**3-B-25-HZ**  
**APPLICATION FOR CERTIFICATE OF APPROPRIATENESS**

**210 Canler Ave. 37921**  
**Mechanicsville H**

# Staff Report

File Number: 3-B-25-HZ

1 MAIN FLOOR PLAN  
 A101 1/4" = 1'-0"

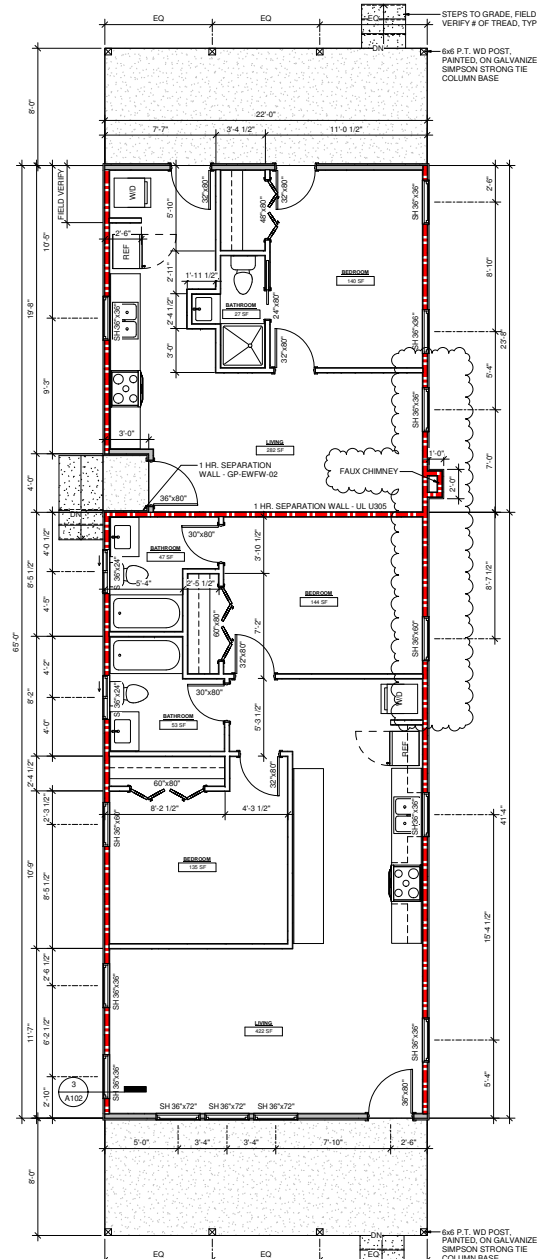
6. Guidelines encourage new construction to feature porches similar to others on the block that are at least 8' deep with wood beadboard ceilings and wood tongue and groove floors. Most houses on the block feature a full-width front porch. The proposed 8' deep porch is similar in design to multiple houses on the block, but the porch flooring and ceiling materials will need to be revised.

10. Guidelines recommend that new buildings use materials consistent with the street and the surrounding neighborhood. Materials are not specified for the proposed windows, but they should be wood or aluminum-clad wood. Most of the windows are 1/1 and single-hung, which are appropriate, but the design includes slider windows which are not a historic window form and should be revised to single-hung or casement operation.

- 2) foundation to be parge-coated or clad in stucco or brick veneer;
- 3) the front porch feature wood tongue-and-groove flooring and a wood beadboard ceiling;
- 4) slider windows to be revised to single or double-hung or casement operation and all windows to be either wood or aluminum-clad wood with wood trim and projecting sills, with final specifications submitted to staff for approval;
- 5) siding material to be wood lap siding;
- 6) front door specifications to be submitted to staff for approval;
- 7) chimney to be clad in brick and extend above the roofline, with a height and size proportionate to historic chimneys in the neighborhood.

6  
A201  
ARCHITECTURAL SITE PLAN  
1/8" = 1'-0"

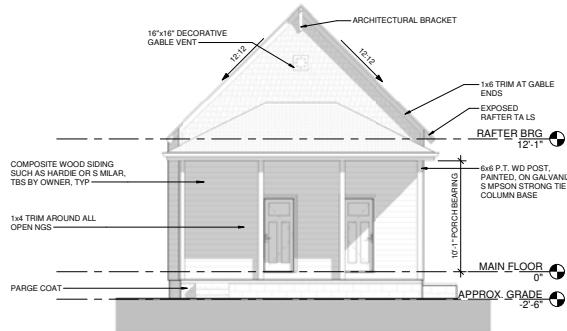
3. Guidelines encourage maintaining the historic façade line of the streetscape and aligning new buildings within the existing setback pattern of the street, which is echoed by the Middle Housing standards (requiring a front setback within five feet, plus or minus, of the blockface average). The average front setback of the blockface is 17.4'. The

house is proposed to be 15.5' from the front property line, with an 8' deep front porch located 7.5' from the front property line. The front and side setbacks are consistent with the block.

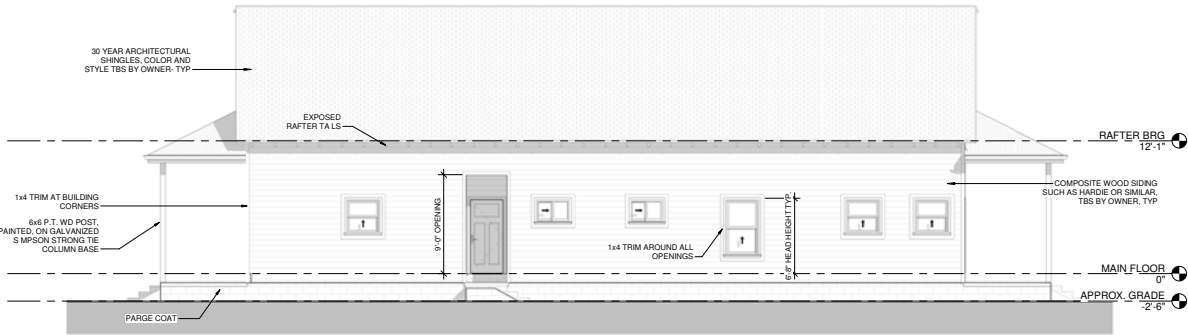
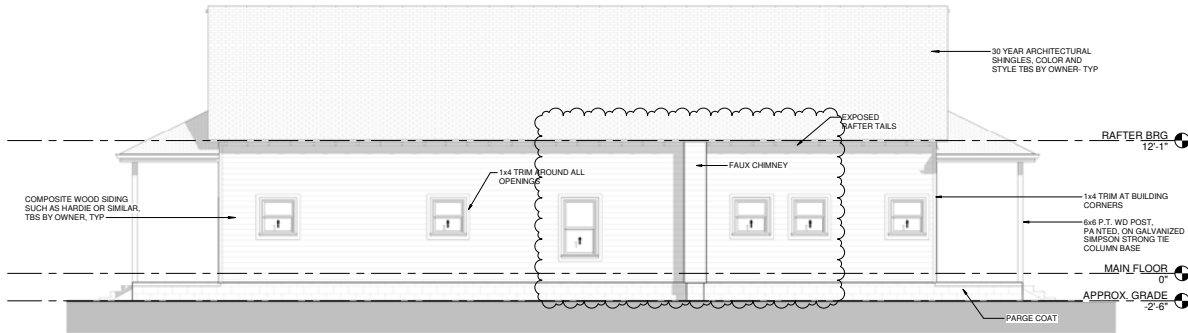
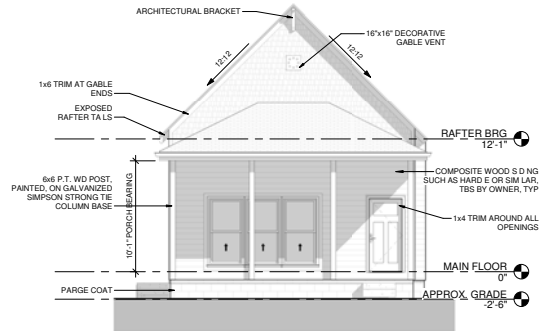
5. Guidelines recommend "break[ing] up uninteresting boxlike forms into smaller varied massings ... by the use of bays, extended front porches, and roof shapes." The proposed duplex uses front and rear porches and a 2' wide chimney to break up the massing, but the Commission should discuss if additional variation is necessary on the large side elevations.

8. Guidelines discourage split-face block. The proposed painted CMU foundation should be clad in stucco, parge-coated, or clad in brick veneer to better align with historic materials in the neighborhood.

9. The guidelines note that "synthetic siding is inappropriate and not allowed [...] as new siding in new construction," limiting "concrete siding (also called Hardi-board) allowed on outbuildings and garages for new construction only." Other historic zoning overlays (including Fourth and Gill, Old North Knoxville, and Edgewood-Park City) have approved fiber cement lap siding (typically with a smooth finish, 4-5" in exposure) on new construction through the design review process, and with the general consent of the neighborhood. However, the Mechanicsville neighborhood has not been supportive of the use of fiber cement siding and the HZC recently required the use of wood lap siding on the adjacent, similar project at 216 Cansler Avenue. The siding material should be revised to wood lap siding.

The chimney on the right elevation should be clad in brick instead of siding, and rest on a brick foundation, to be compatible with the historic chimneys in the neighborhood. The chimney should also extend above the roofline with a height and width proportionate to other historic chimneys in the neighborhood.
